# Access Compliance Report

## Public Rights-of-Way

Intersection ID: 44822	Main Street: GOLDEN_RIDGE_LN	Cross Street: HIRAM_ST	Location: SE
ADA ID: 79C1F7C11E25	Ramp Type: PerpDiag	Initial Pass/Fail: Fail	Overall Compliance: No
Codes/Mitigation Info/Possible Solution			Severity Score: 10
			Field Measurements/Component Compliance

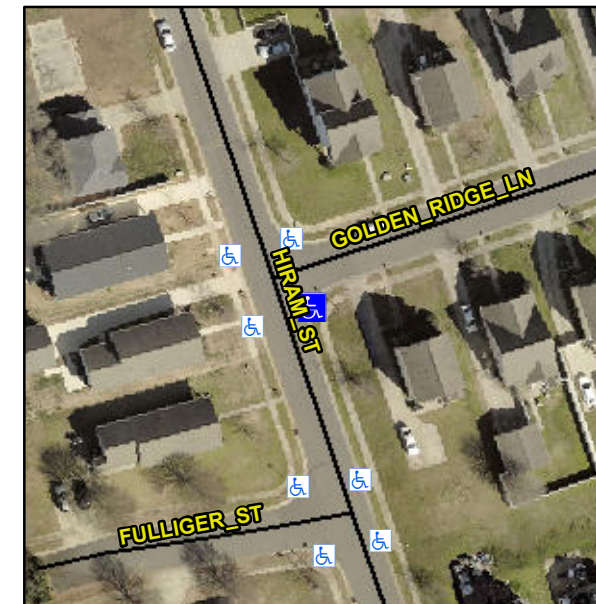
**R304.5.1, R304.5.3**

Compliance	Description	Data	Compliance	Description	Data
N/A	Ramp Length (in)	49.0	Yes	Ramp Slope (%)	5.4
No	Ramp Width (in)	42.5	No	Ramp XSlope (%)	4.1
N/A	Flare Type LT	N/A	N/A	Flare Type RT	N/A
N/A	Flare Slope LT (%)	N/A	N/A	Flare Slope RT (%)	N/A
N/A	Flare Traversable LT?	N/A	N/A	Flare Traversable RT?	N/A
N/A	Landing Length (in)	N/A	N/A	DWS Provided?	N/A
N/A	Landing Width (in)	N/A	N/A	DWS Contrast?	N/A
N/A	Landing Slope (%)	N/A	N/A	DWS Length (in)	N/A
N/A	Landing X Slope (%)	N/A	N/A	DWS Full Width?	N/A
N/A	Landing Curb? (Y/N)	N/A	N/A	DWS Offset (in)	N/A
N/A	Shared Landing?	N/A			
N/A	Gutter Ponding?	N/A	N/A	Gutter Slope (%)	N/A
N/A	Gutter Lip Ht (in)	N/A	N/A	Gutter X Slope (%)	N/A
N/A	Painted X Walk1?	No	N/A	Painted X Walk2?	No
	X Walk 1 Direction	To N		X Walk 2 Direction	To W
N/A	X Walk 1 Width (in)	N/A	N/A	X Walk 2 Width (in)	N/A
	X Walk 1 Slope (%)	8.7		X Walk 2 Slope (%)	5.0
	X Walk 1 X Slope (%)	6.4		X Walk 2 X Slope (%)	4.1

N/A	Ramp inside XWalk1?	N/A	N/A	Ramp inside XWalk2?	N/A
	Road Slope (%)	1.5	N/A	Clear Space?	N/A
	Road X Slope (%)	10.0	N/A	Clear Space to XWalk (in)	N/A
N/A	Any Obstructions?	N/A	N/A	Storm Grate/Utility Hazard?	N/A
	Obstruction Type			Storm Grate/Utility Type	
		N/A			N/A
			Yes	Surface Condition? (G/P)	Good

**Remove & Replace Curb Ramp With Two New Directional Ramps or Equivalent.**
